Network Camera Firmware

Version: V5.5.80

Release Note (External)

(2018-09-14)

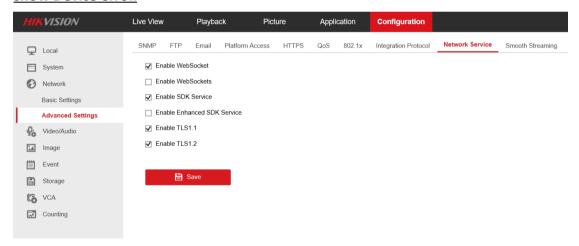
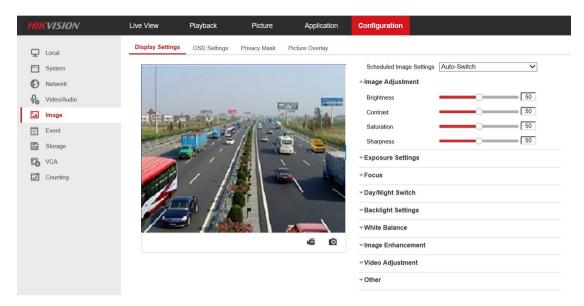
• Newly add 'Start Recording' and 'Capture' bottom on Web-Configuration-Image interface, to save picture or clip to local.

Newly add Auto mode of BLC (Backlight Compensation) Area. When enable HLC (High Light Compression) and auto mode BLC Area at the same time, HLC works, auto mode BLC does not work.
